Town of Breckenridge
Planning Commission Agenda
Tuesday, July 5, 2011
Breckenridge Council Chambers
150 Ski Hill Road

PLANNING COMMISSION MEETING

- Project Manager:** Michael Mosher, Planner III
- Date:** June 22, 2011 (For meeting of July 5, 2011)
- Subject:** The Elk, Mixed Use Building and Variance Request (Class A, Final Hearing; PC#2011001) - *(The last meeting was a second preliminary hearing.)*

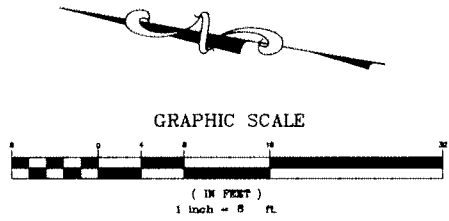
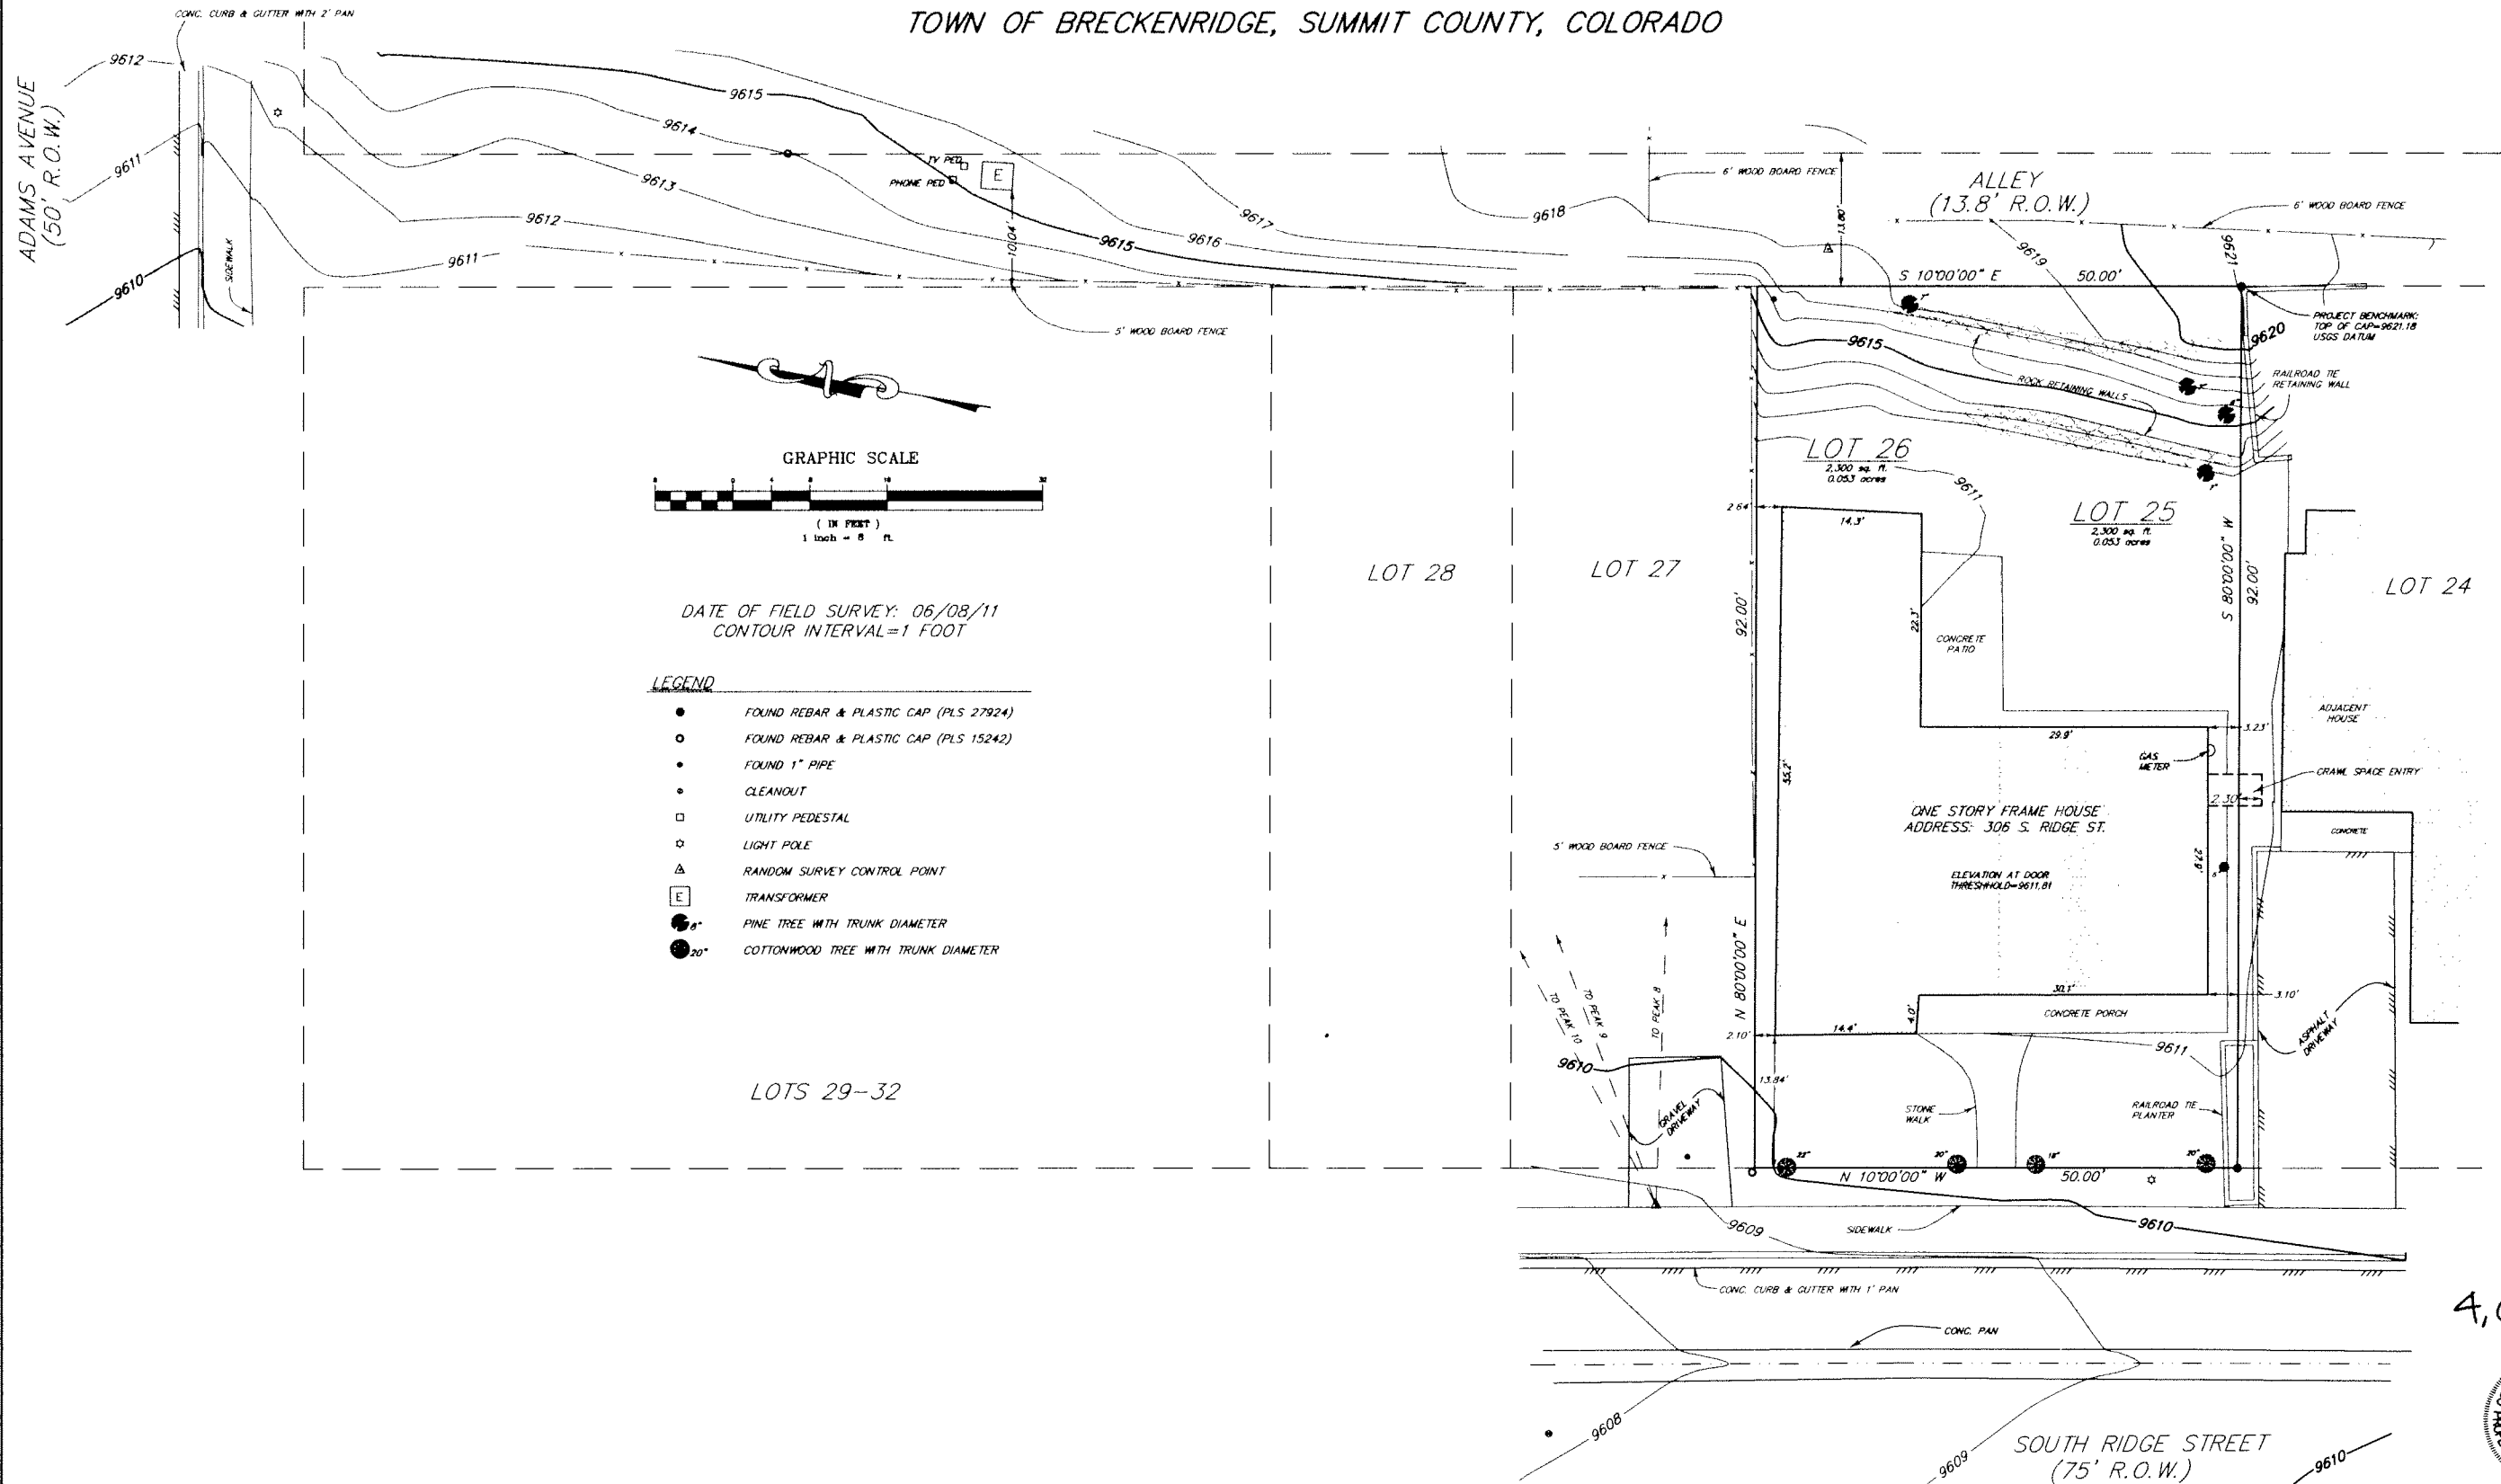
At this early design phase, the applicant is seeking to add to the back of the historic structure with a connector (that will abide with Priority Policy 80A of *The Handbook of Design Standards for the Historic and Conservation Districts*).

(Only if the alley access option is used:) To create the garage access off of the alley behind the house, the floor of the proposed garage would be 9-feet higher than the floor elevation of the historic house. The one-story house is 18-feet tall to the ridge. The proposed garage is matching at 18-feet to the ridge. Overall, the new one-story garage would be 9-feet higher than the house as viewed from Ridge Street.

The façade of the proposed garage would be 48-feet behind the façade of the historic house. The inside separation between the historic house and the face of the garage is 33-feet. The grade of the back yards of the neighboring historic properties to the east (above the alley) sit about 10-feet above the alley grade and subsequently are about 18-feet taller than the Shetterly House.

Given the physical constraints of the property and the large grade differential between the neighboring lots, Staff believes the addition of the proposed garage and living area will have minimal impact and meets the intent of the design standards and policies.
